COMMUNITY SERVICES COMMITTEE**14 MAY 2014****3****WHITFIELD HILL RECREATION FEASIBILITY STUDY - PUBLIC CONSULTATION FEEDBACK**

Attachment 1: Concept plan – Whitfield Hill outlining current and future tracks with the link to the Blue and Red Arrow Walking Tracks

Attachment 1: Concept Plan: Whitfield Hill outlining current and future tracks with the link to Blue Arrow walking track

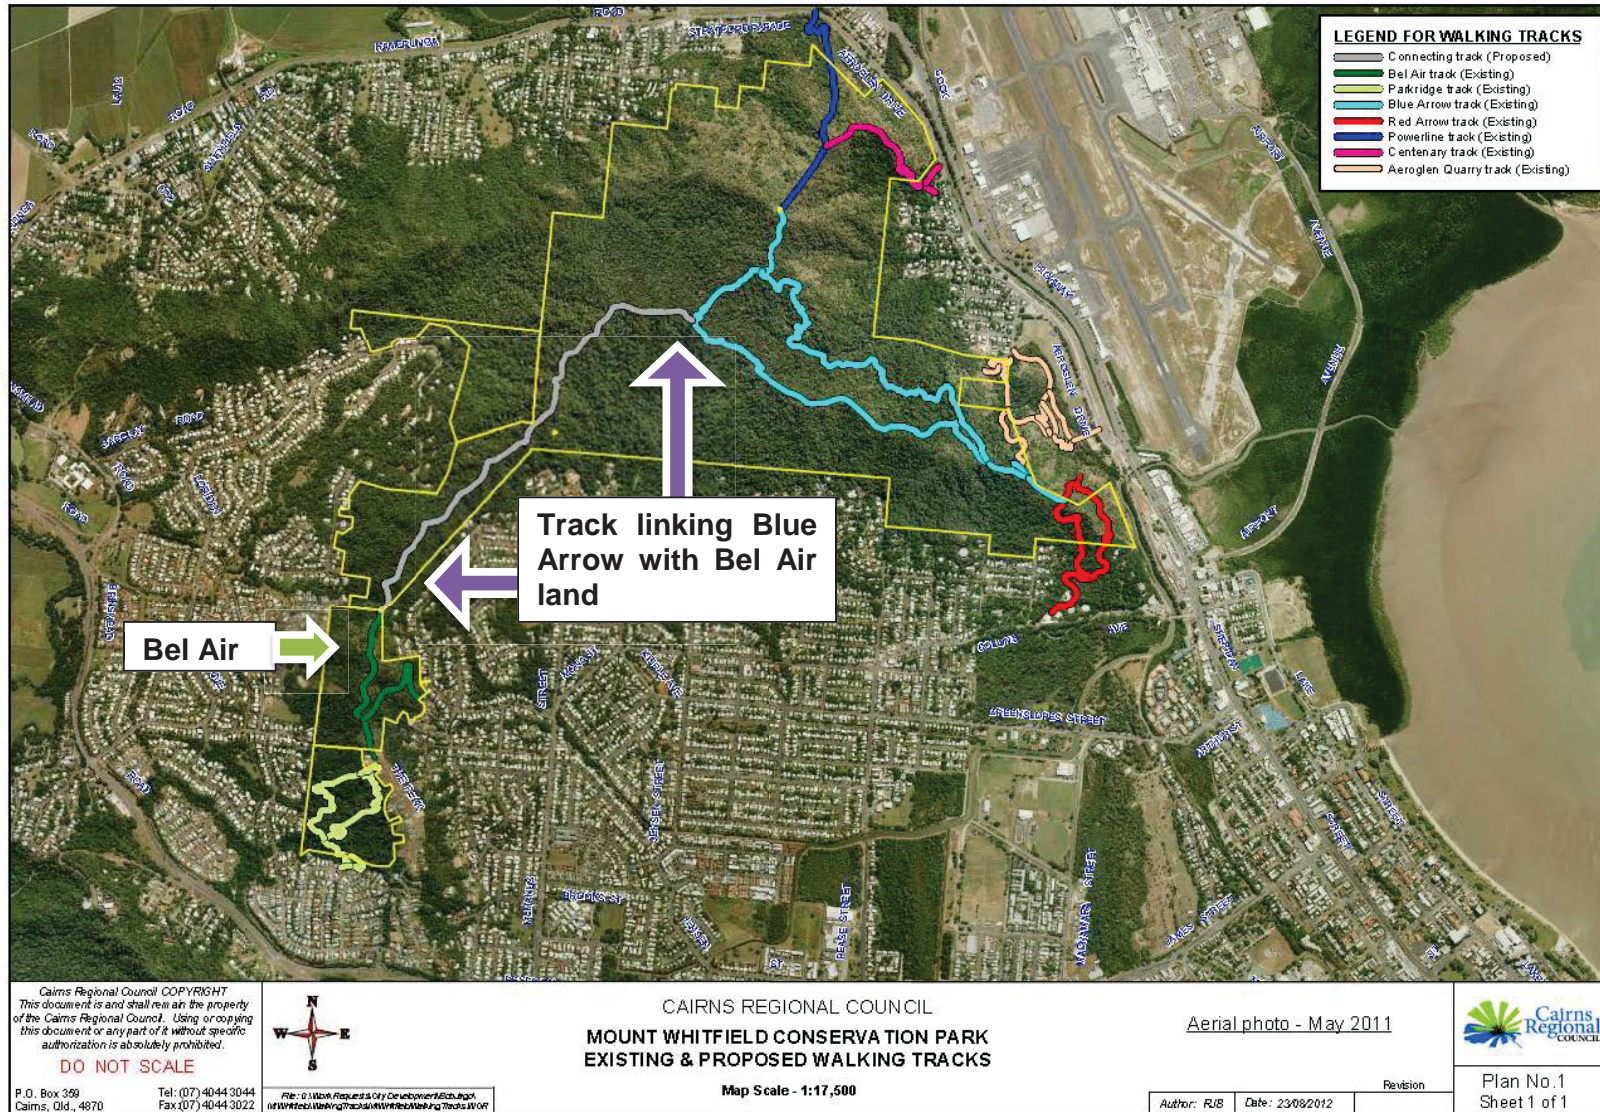
Issue	Council Recommendation
Traffic	
Increased traffic – risk of accidents at all the entrances, increased safety risk to families who live in the area, will require traffic calming especially in Hodel St.	No formal parking to be provided in Bel-Air at this stage. This should limit any increase in traffic volumes.
Possibility of attracting more Commercial uses (eg early morning bootcamps) - increased traffic and noise at extremely early and late hours.	
Speed bumps should be factored into the equation - high speed driving in Hodel St. A walking track with car access on the hill will exacerbate this and make life less pleasant for those living close by.	The issue of speed bumps will be investigated and evaluated.
Antisocial Behaviour	
Will attract criminals trying to rob and sexually assault exercisers. Not wanted near Hodel St.	Noted
Impact on the Natural Landscape	
Little regard given to the protection of the natural environment and in particular the birdlife and fauna which will be impacted by the increased number of dogs in the area.	Dogs will only be allowed on the Bel-Air site as the walking track which will join to the Blue Arrow will be on State land and is subject to legislation which prohibits dogs.

Path connecting to Red Arrow should be for nature walkers only, as joggers badly erode the path and spoil the enjoyment of nature walkers, likewise cycling and dogs would spoil the amenity and wildlife.	
Loss of amenity and property values	
The property valuations will decrease if the site is accessed via access street/place.	Noted.
Access should be from the Red and Blue Arrow walk.	This will be viable and practicable.
Parking	
Request for installation of traffic calming devices on Hodel St due to additional traffic.	Council will evaluate this request.
Kids are dropped off by parents and having out of control parties on Whitfield Hill - by providing parking will make it more convenient for them.	No formal parking at the top of Bel-Air Drive is to be provided at this stage.
The building of a car park at the top of Bel-Air Drive, will result in a raised security risk by increasing loiterers at night, additional traffic and increased rubbish.

Provision of a car park at the top of Bel-Air will encourage people to sleep in their cars, parties and generally disturb the quiet neighbourhood.	
Sealing the end of Bel-Air Drive will decrease the amenity of the local area.	
Not supportive of the car parking in Bel Air Drive I suggest end of Bolton St a play area that has many attributes that make it a more suitable location. This street was, with or without future subdivision, always going to be a limited access, therefore limited use road.	
No benefit	
This initiative represents an additional cost to the council - there has been no study undertaken that states the Red and Blue Arrows are insufficient.	Funding is being sought from the State Government to partially fund this project.
